Fire technical assessment

Name of sponsor: Bygcom A/S
Product name: Symmetrical 1-layer gypsum wall - REI30
File no.: PHA11192C
Date: 28-05-2019
Pages: 4 **Encl.:** 1
Ref: MKL / NOL

Loadbearing wall – REI30

REI30 Max. 3m høj, last maks. 28kN/m.

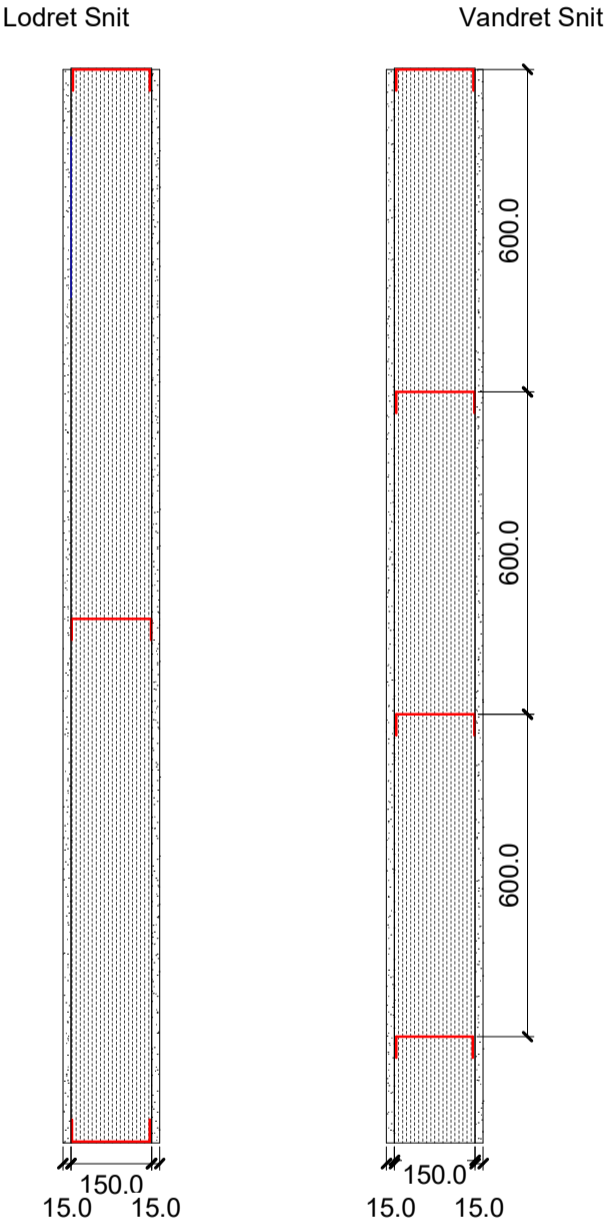
The construction shown on the attached drawing consist of one layer of 15 mm Fermacell fibre boards on each side of cc 600 mm steel studs with a width of 150 mm and a steel thickness of 2.0 mm designated Bygcom 150x2.0. Stone wool insulation with a nominal density of at least 45 kg/m³ is mounted between the steel studs.

The only changes to the assessed wall is the type, thickness and placements of the studs. The change in stud type and the increase in stud thickness will not deteriorate the performance of the wall and can in some cases improve the stability of a wall during a fire test.

Based on the given documentation, DBI assesses that the wall shown on the attached drawings fulfils the requirements for a loadbearing wall with the classification REI30.

- The following changes are allowed (taken from the DIAP in EN 1365-1:2012)
 - Decrease in load (max 21.4 kN/m)
 - Decrease in height (max 3000 mm)
 - Increase in the thickness of the wall (minimum 180 mm thick)
 - Increase in the thickness of component materials
 - Decrease in linear dimensions of boards but not thickness
 - Decrease in stud spacing
 - Decrease in distance of fixing centres
 - Increase in the number of horizontal joints
 - Unlimited increase of the width of the wall
- All other details must be constructed as described in test report FIRES-FR-126-08-AUNE
